ARLINGTON COUNTY, VIRGINIA

County Board Agenda Item
Meeting of January 21, 2012

SUPPLEMENTAL REPORT-REVISED CONDITIONS

SUBJECT: SP #386 SITE PLAN amendment application of BDC Crimson LLC, for the construction of a 201,627 square foot commercial building with 178,131 square feet of office space, 3,200 square feet of ground floor retail, a 12,985 square-foot black box theater, and a comprehensive sign plan in the C-O-2.5 zoning district under Section 36.H. Property is approximately 45,508 square feet; Modifications of zoning ordinance requirements include: parking ratio, increased sign area, freestanding sign, changeable copy signage, and surface parking as an interim use, exclusions from density for the theater, below-grade storage and a below-grade fitness facility, bonus density for LEED Gold certification, affordable housing contribution, specific construction problems and techniques needed for the black box theater, open space and environmental amenities, and other modifications as necessary to achieve the proposed development plan (RPC# 14-030-057and -058).

ADDED AREA OF CURTAINWALL
ON WEST ELEVATION

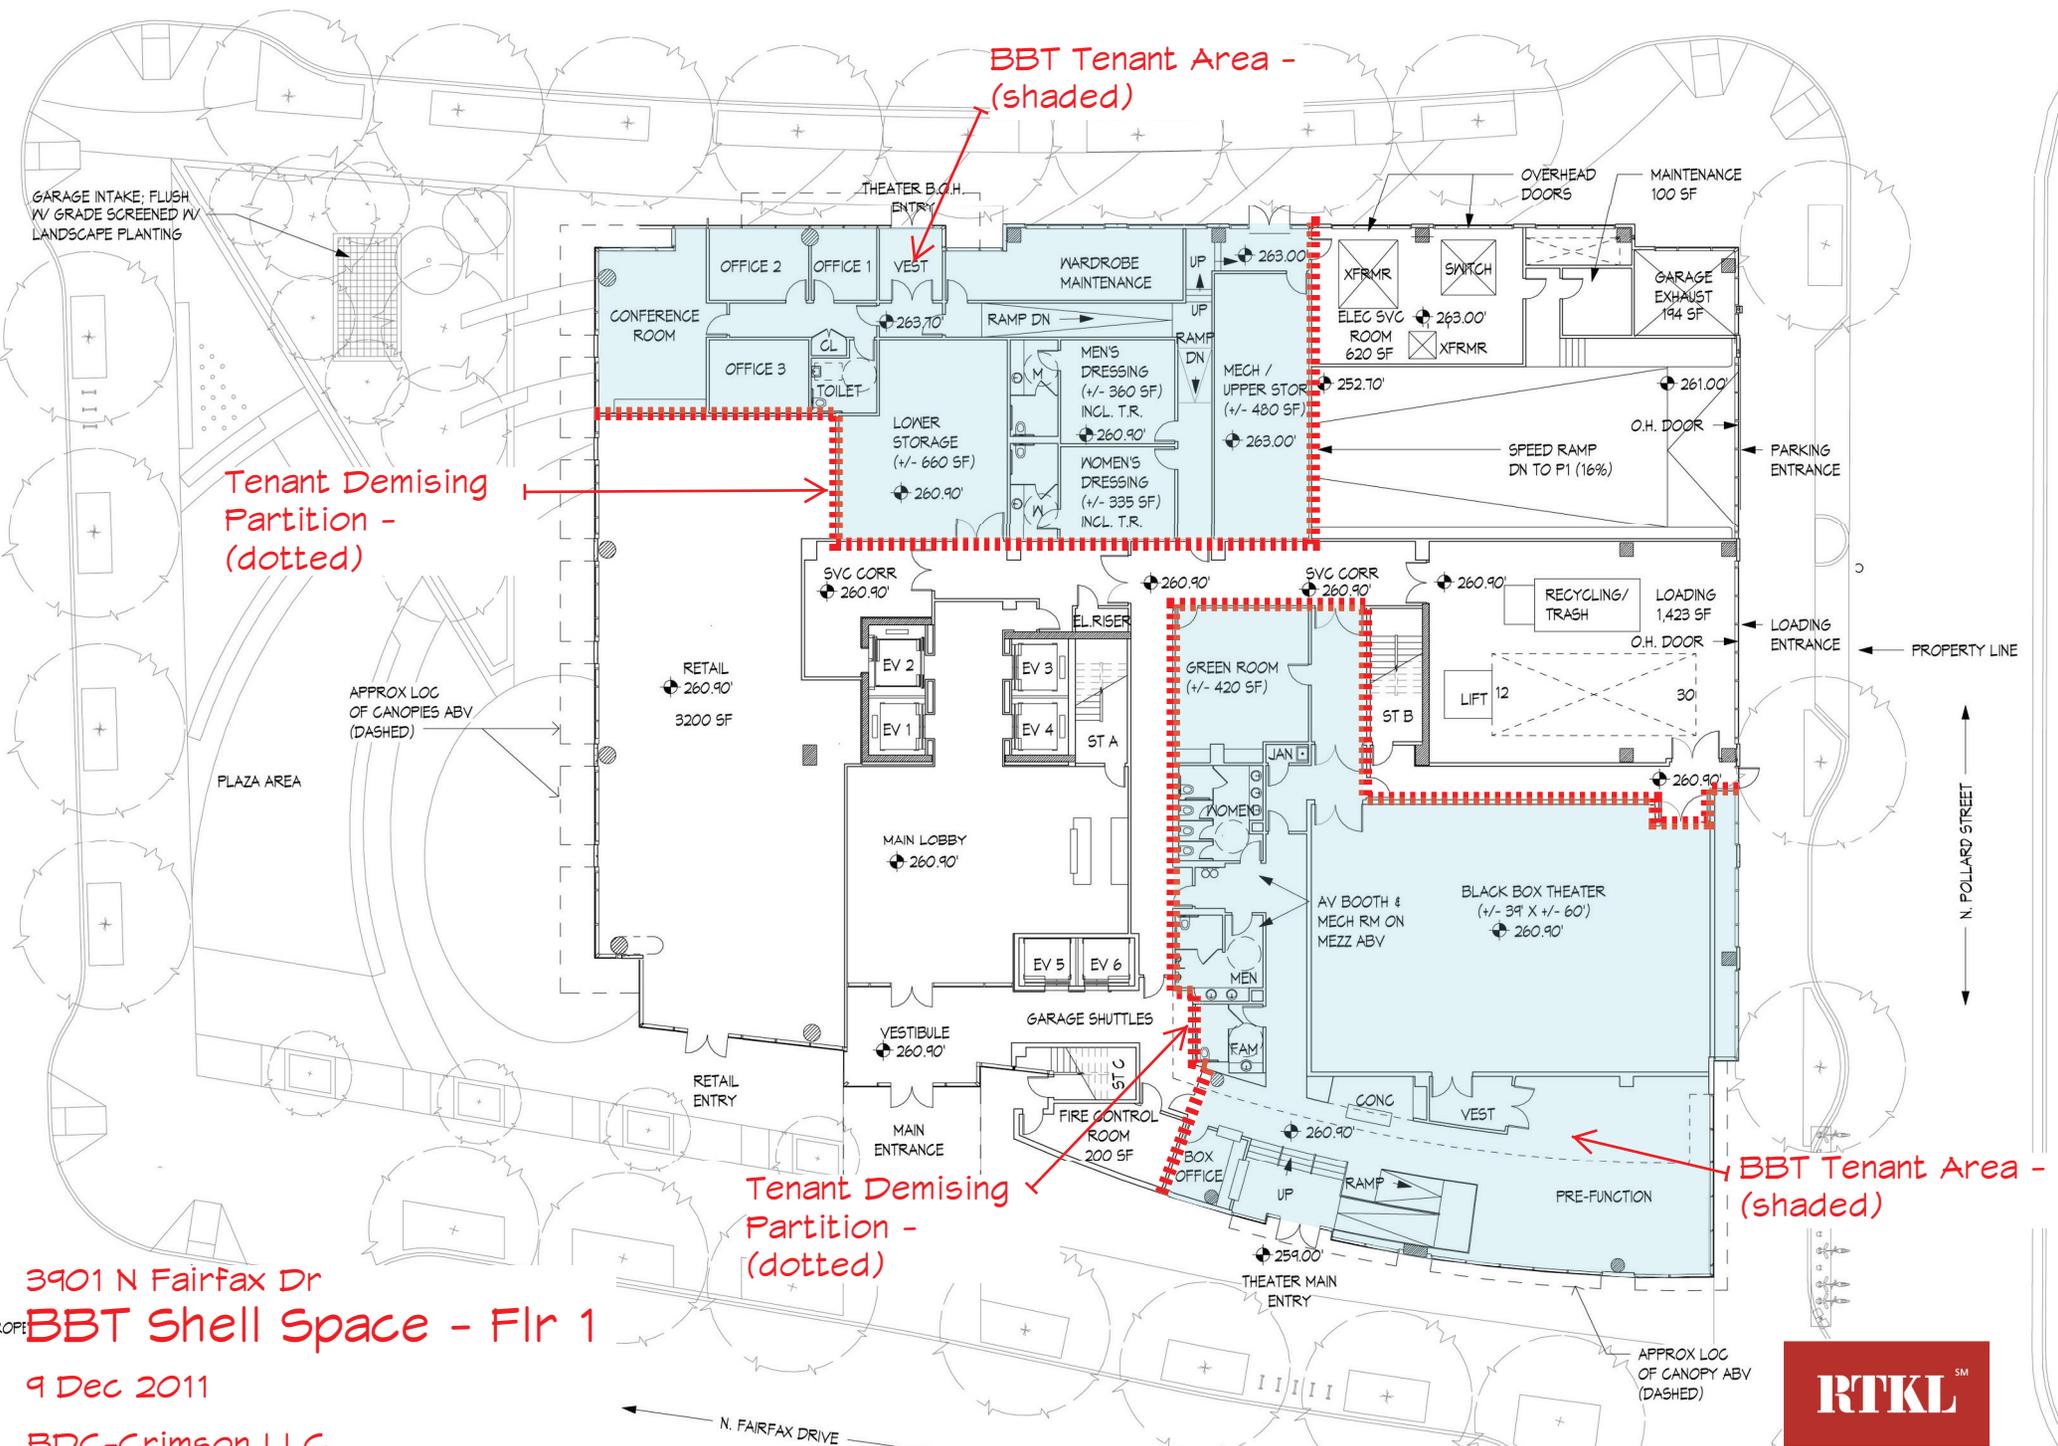
West Building Façade Design: In response to community and Planning Commission comments that the west building façade should be more prominent, the developer has revised the west

building façade to incorporate a glass bay near the southwestern corner of the building (See Figure 1). Specifically, comments were made that the North Quincy Street façade should be treated to some degree as a “front,” since it is facing a plaza (approximately 12,000 square feet in size) and the corner of a busy intersection. The concern was raised that this west façade does not have elements that relate it to the main frontage on Fairfax Drive. The developer has incorporated an enhanced treatment of the building’s west façade near the southwestern corner of the building that consists of a vertical glass curtain wall. Staff supports this additional treatment on North Quincy Street as it modulates the façade and integrates well with the Fairfax Drive frontage. Based on the current plaza design concept, the west frontage also will have a significant three-dimensional element, a large tension cable canopy structure that is mounted onto the building and shades the plaza. The plaza itself is also the key prominent feature on the North Quincy Street frontage.

The revision to the west façade technically impacts several conditions of approval for this site plan, since an additional drawing is being added to the December 9, 2011 plan package already referenced in throughout the proposed conditions. Conditions 1, 15b, 19, 41, 44, 65, 66, 69, 72, 82, and 87 are included in this report with an additional clause that references a new drawing of the west elevation entitled Revisions to West Elevation dated January 13, 2012.
